RESEARCH REACTOR CENTER

Reference: Docket 50-186
University of Missouri-Columbia Research Reactor
Amended Facility License R-103

SUBJECT: Written communication as specified by 10 CFR 50.4(b)(1) regarding the response to the
“University of Missouri at Columbia – Request for Additional Information Re: License
Renewal, National Historic Preservation Act (TAC No. MD3034),” dated April 30, 2010

ATTACHMENT 6

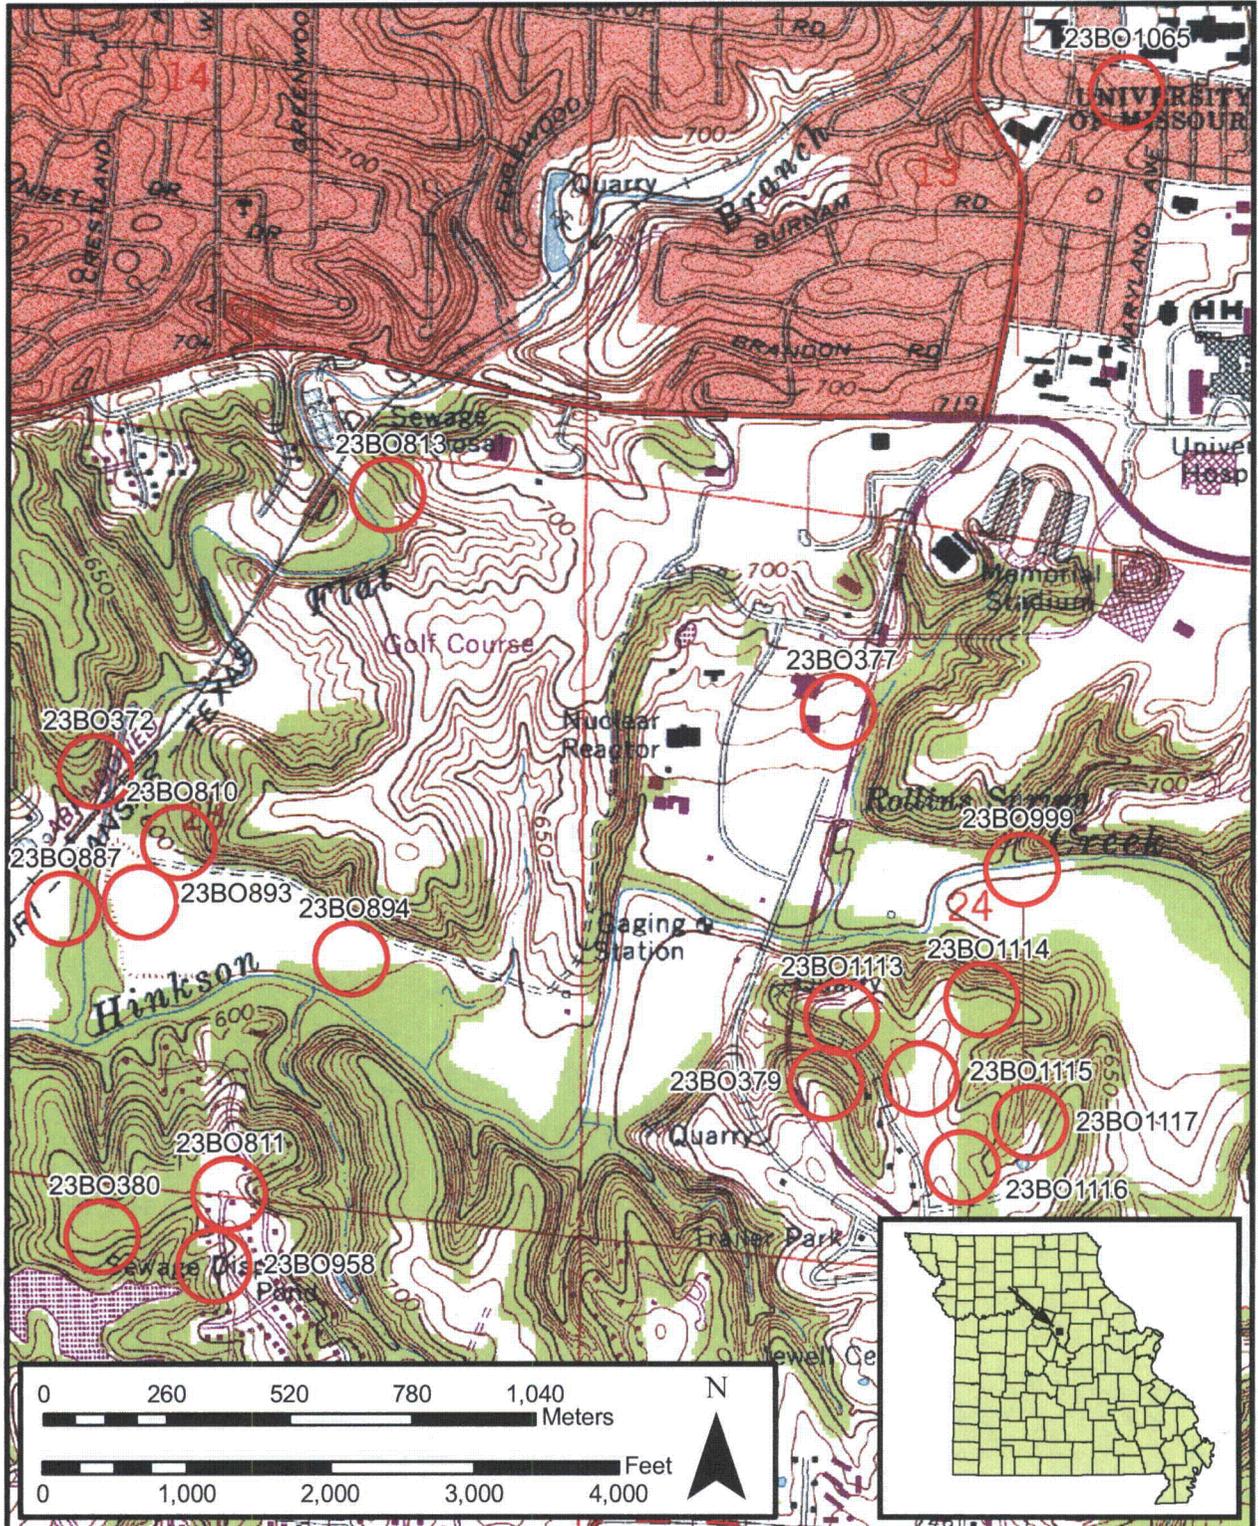
3. *Please state if you are aware of any archaeological sites on or adjacent to the MURR site. If so, identify them on the topographic map.*

A review of the archaeological records of the Missouri Department of Natural Resources and the Archaeology Survey of Missouri found no evidence of archaeological sites on the 7.5 acre MURR site. The nearest recorded archaeological site is approximately 1000 feet (304.8 m) from the facility. See attached topographical map (Attachment 6).

ATTACHMENT 7

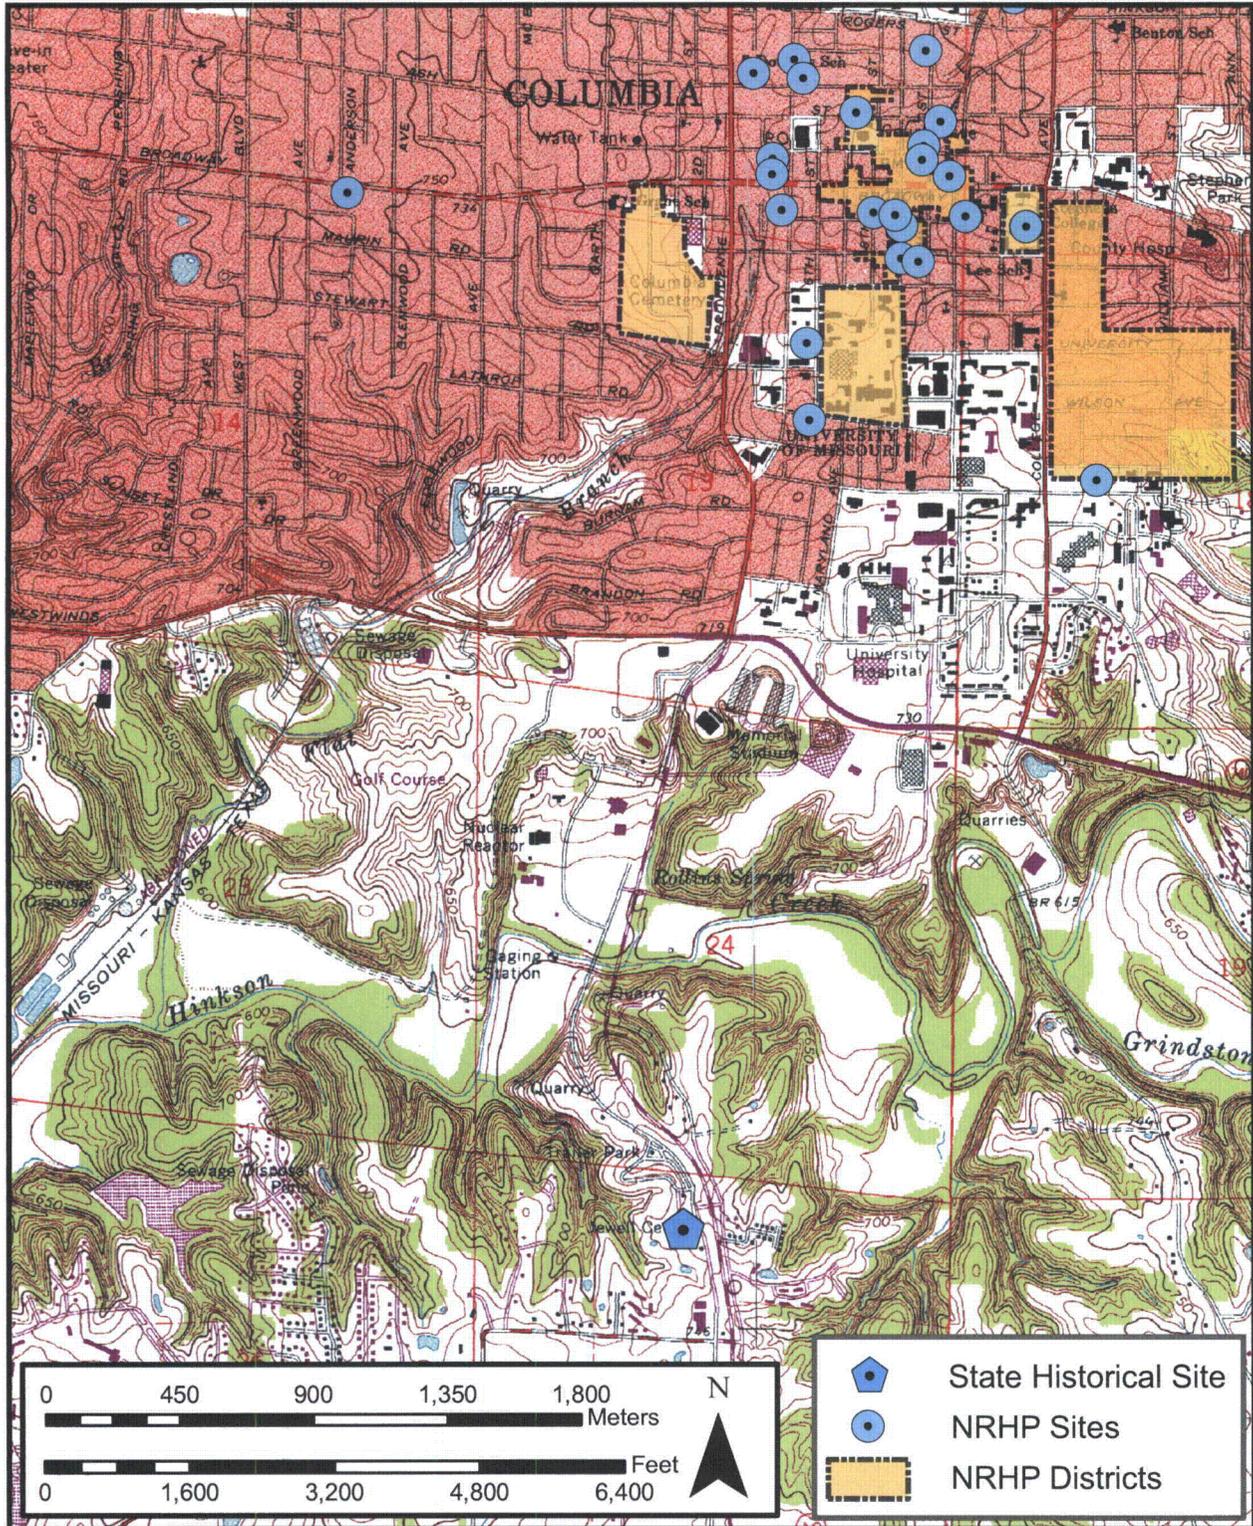
4. *Please state if the MURR is located in an area previously surveyed for historic properties, or a National Register District, or a local historic district. If so, please provide the name of the survey or district.*

The attached topographical map (Attachment 7) illustrates the proximity of National Register Sites, National Register Districts, and Certified Local Districts to the facility. There are no National Register Districts, or local historical districts on or near the 7.5 acre MURR site.

The closest National Register site, the Sanford F. Conley House, is located approximately one mile (1.6 km) from the facility. A State historic site, the Jewell Cemetery, a 0.45 acre historic cemetery, is located approximately 0.9 miles (1.5 km) from the MURR site.
